Vermont Agency of Transportation
RECEIVED
CK'D BY RK/GL OK'D BY WL
February 19, 2015
RESUBMIT YES Rejected
BY KH DATE 3-5-2015

Project: HARTFORD LATERAL BRIDGE
I-91 NORTHBOUND

Drawing: ABUTMENT 3 W/ WINGWALLS 5&6 REINFORCEMENT

FILE NAME: s12a132retwall.dgn
PROJECT LEADER: K. HIGGINS
DESIGNED BY: C. LAROCHE
RETAINING WALL #8

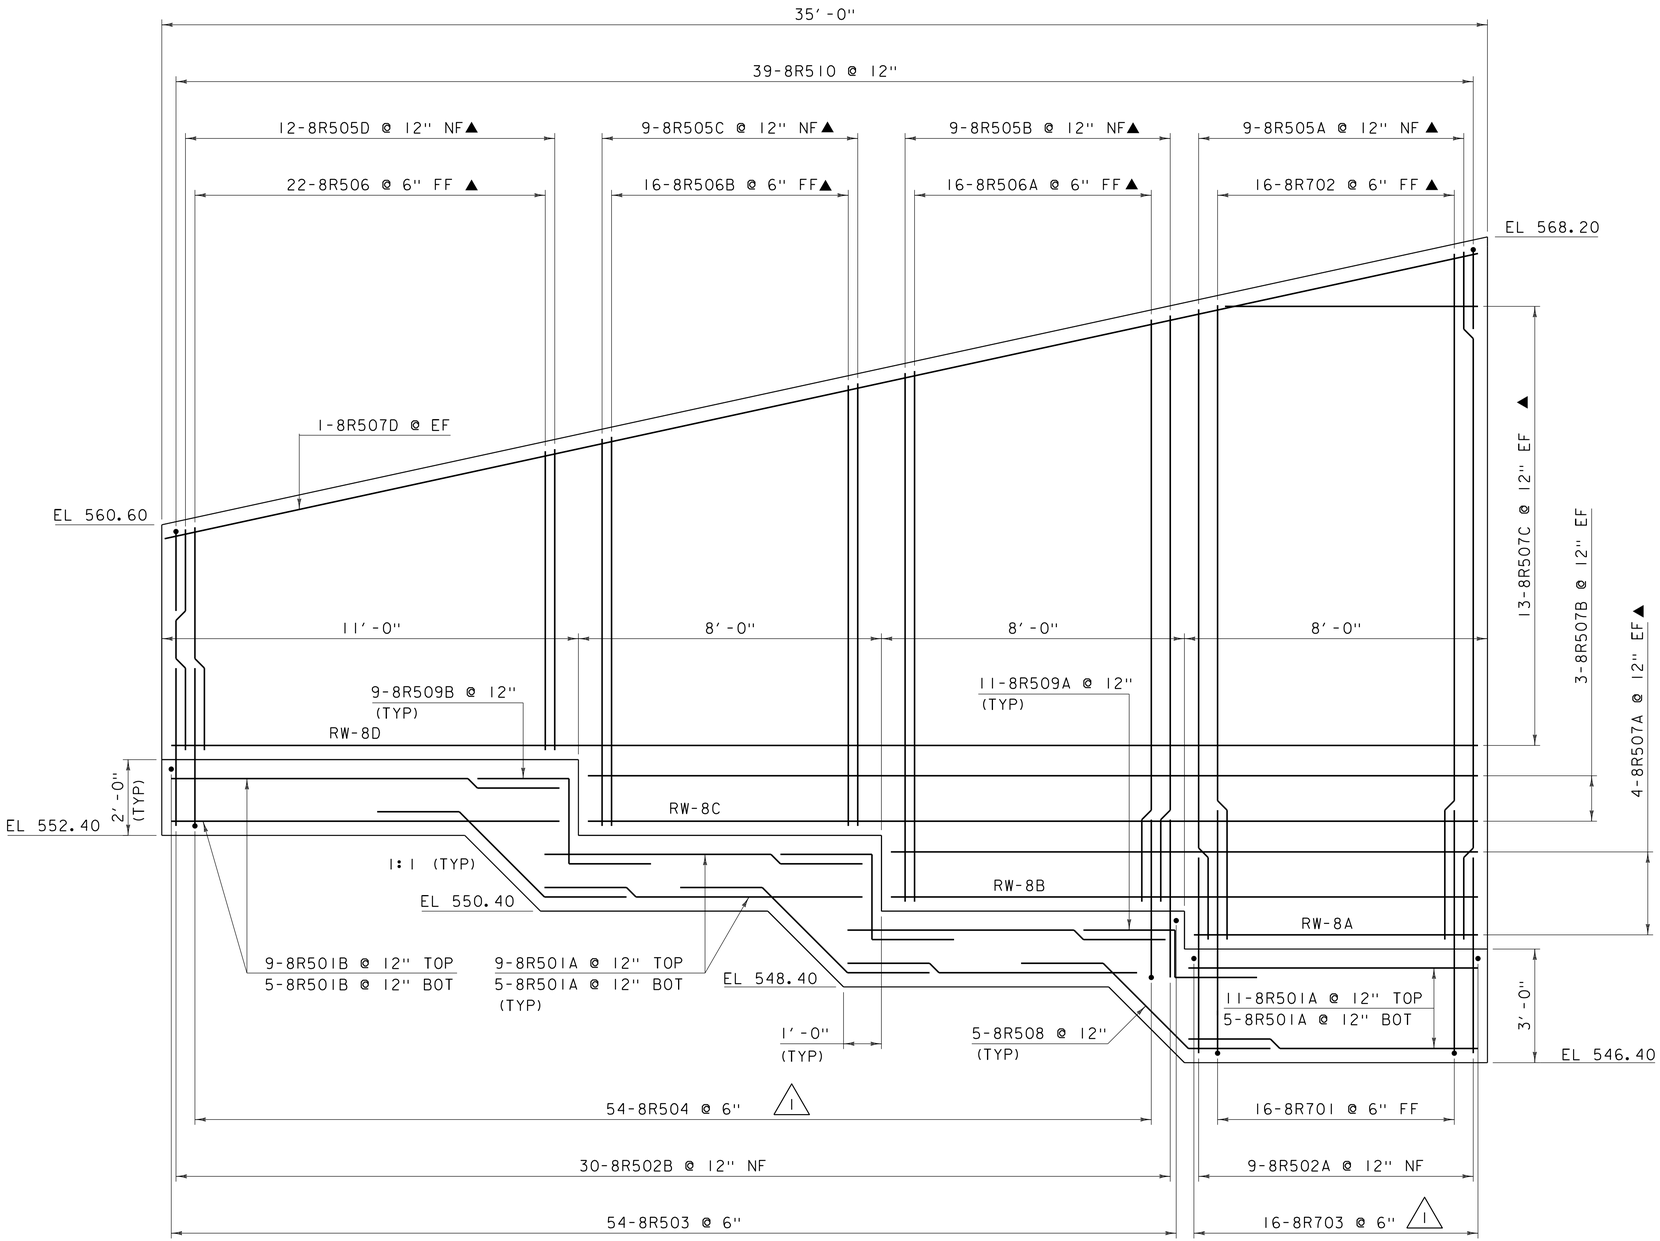
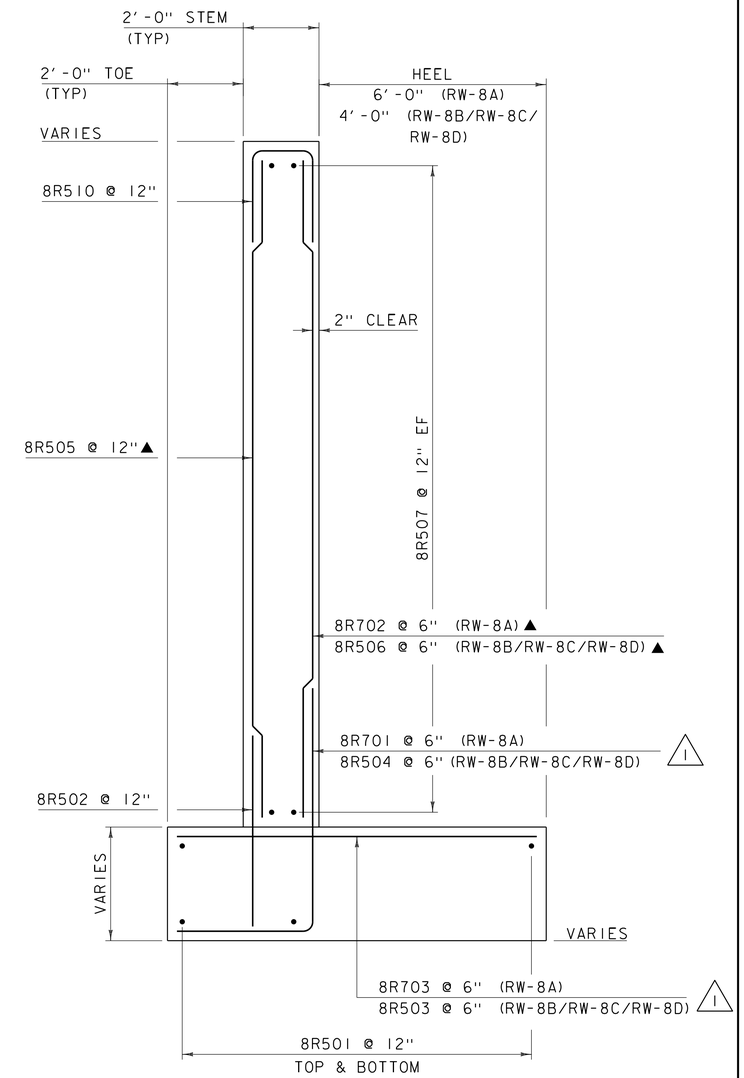
REVISION	DATE	DESCRIPTION	BY
1	03-05-2015	BAR CHANGES PER DESIGN	JS
